**CONSTRUCTION CONTRACT CHANGE ORDER NUMBER:** 1

**Project:** Flashing Beacon

# Change Order #1 Flashing Beacon Project

Project: Flashing Beacons  
Contract: C-21-0686-10-19  
Limits: Carman Avila & Mile 22 ½ N

**FLASHING BEACON PROJECT**  
**FLASHING BEACON LAYOUT**  
**CARMEN AVILA RD AND**  
**MILE 22 1/2 N**  
 SHEET 1 OF 1

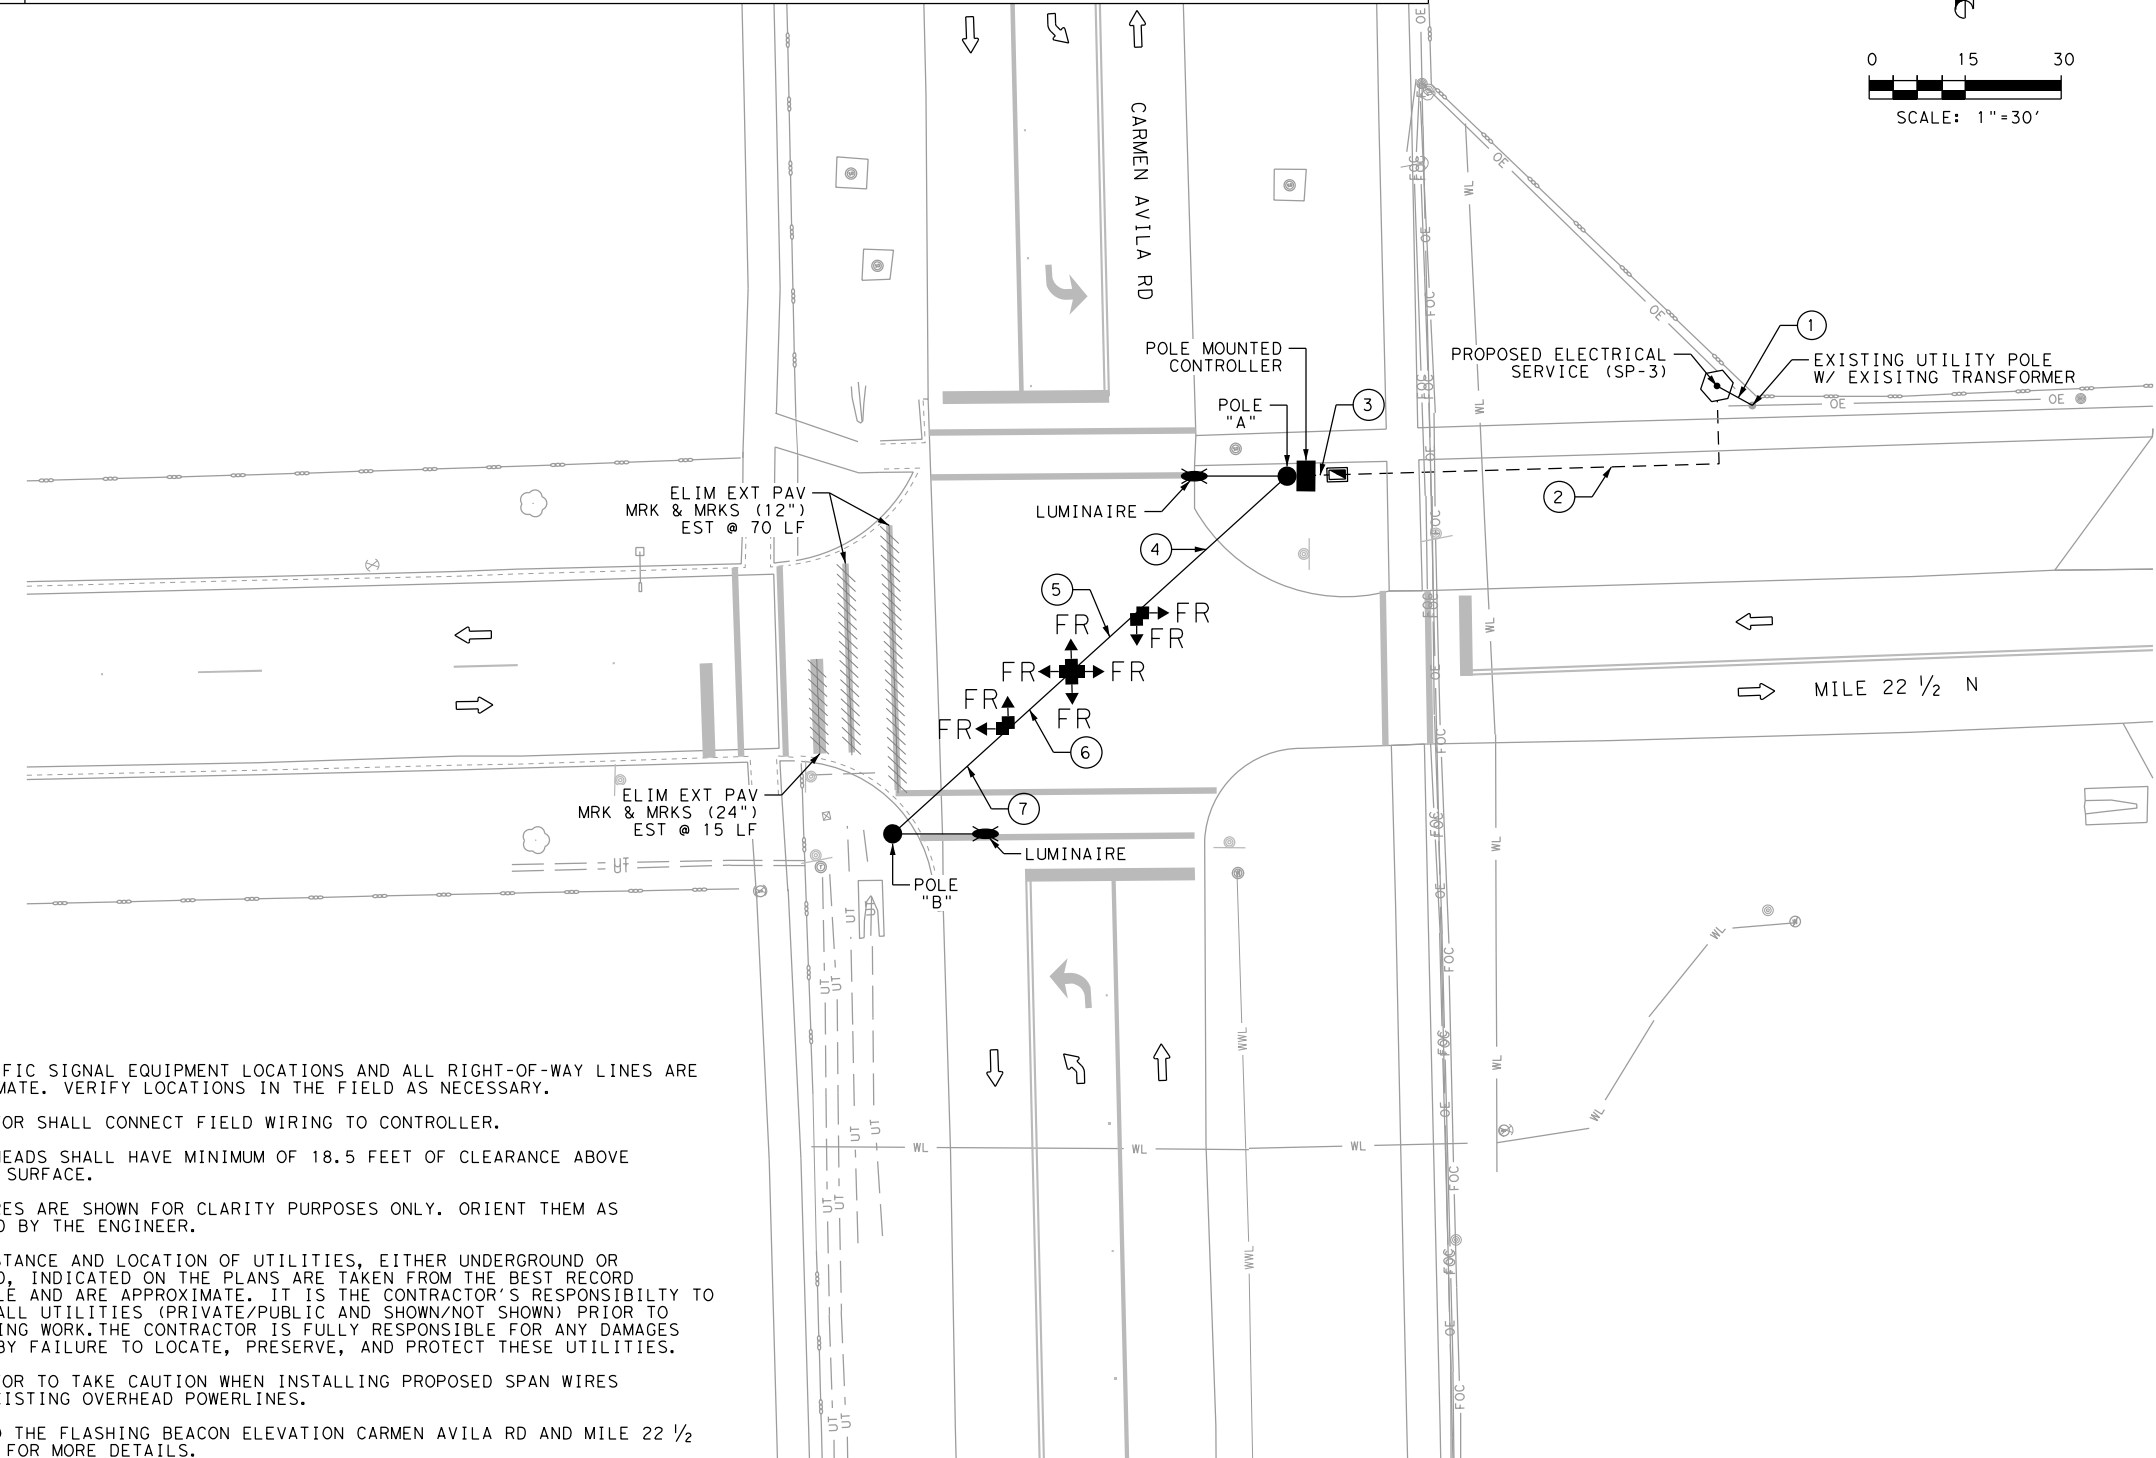
Change Order #1 is for an additional intersection to be added. 10<sup>th</sup> St and Chapin St Intersection along with the Rogers Road and Depot Road Intersection were on the original contract. This CO will add Carmen Avila and Mile 22 1/ 2 N Intersection to the original contract.

We offer field change pricing to construct a span wire flashing beacon signal system at Carmen Avila & Mile 22-1/2 N in accordance with the plan sheets dated 6/9/2022. Additional bond cost for this added work is included in our pricing. Signal pole lead-time is approx 16 weeks after submittal approval and pole release. This proposal expires on 7/31/2022 as that is when the vendor quote for the signal poles expires.
